UNITED STATES PATENT AND TRADEMARK OFFICE

APPLICATION NO.	FILING DATE	FIRST NAMED INVENTOR	ATTORNEY DOCKET NO.	CONFIRMATION NO.
09/817,843	03/26/2001	John U. Knickerbocker	END000008US1	9394

Office Action Summary

DETAILED ACTION

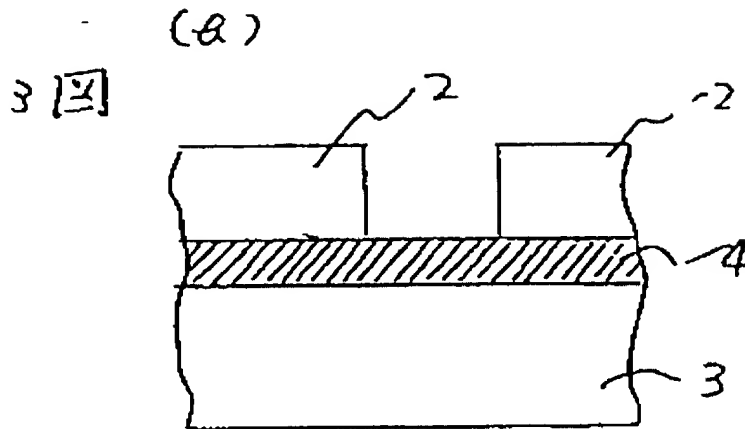
5. Claims 35 and 36 are rejected under 35 U.S.C. 102(b) as being anticipated by Onda (JP-03296238 A).

6. Regarding claims 35 and 36, Onda (e.g. fig. 3b) teaches an electronic package having a selectively controlled contact pad-laminate surface adhesion comprising: a dielectric packaging substrate 3/4 having a major surface (top surface); and a copper foil 2 laminated to the major surface wherein the copper foil has one side having an smooth portion thereof (bottom surface). Also, the smooth portion contacts the major surface of the dielectric package and has a surface roughness of less than about 1 micron (see attached translation, claims 1-4 and page 2, pp. 6).

Fig.6

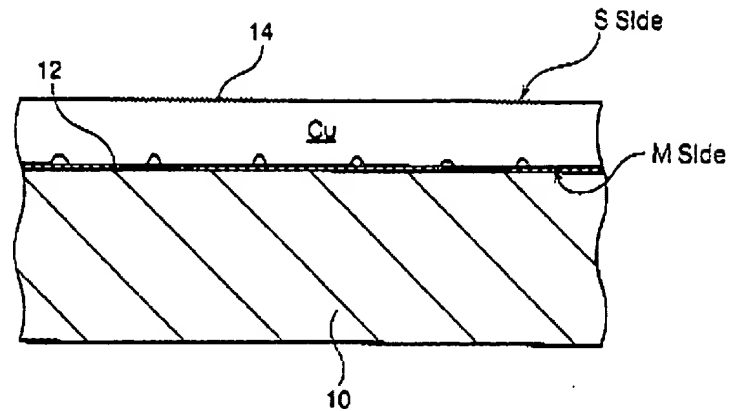
10. Regarding claims 1 and 35, Kurabe (e.g. fig. 6) teaches an electronic package having a selectively controlled contact pad-laminate surface adhesion comprising: a ball grid array package (col. 1/lls. 7-15; col. 14/lls. 28-27) including a dielectric packaging substrate 10 having a major surface (top surface); and a copper foil laminated to the major surface wherein the copper foil has one side having an smooth portion (M side) thereof. The smooth portion contacts the major surface of the dielectric package and has a surface roughness of less than about 2 micron (see abstract & col. 12/lls. 55-67).

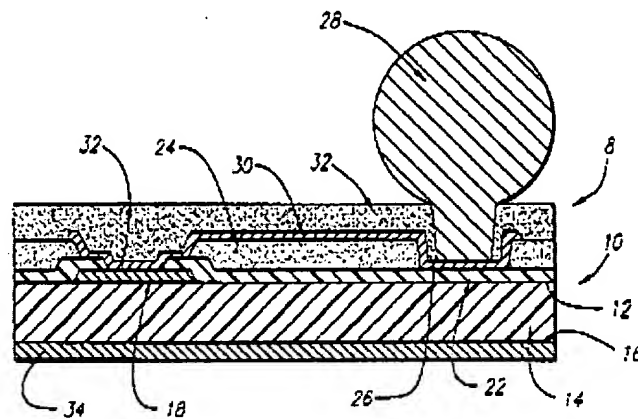
13. Regarding claim 17, Elenius (e.g. figs. 1 and 2) shows an electronic package comprising a ball grid array package (see the array formed by solder balls 26; see top view) having a semiconductor packaging substrate 12 having a major surface; a first mechanically compliant dielectric layer 22 formed over the major surface of the substrate and having at least one first opening formed therethrough; a first electrical contact pad 18 formed in the first opening and in electrical contact with the substrate; a second mechanically compliant dielectric layer 24 formed over the first compliant layer and having at least one second opening formed therethrough wherein the second opening is substantially offset from the first opening; a second electrical conductive pad

30 formed in the second opening and extending over a portion of the first electrical contact pad and contacting the first electrical contact pad; a mask layer 32 formed over the second compliant layer and having a third opening therethrough in communication with the second electrical contact pad; and a solder ball 28 solderably connected to the second electrical contact pad and extending through the third opening.
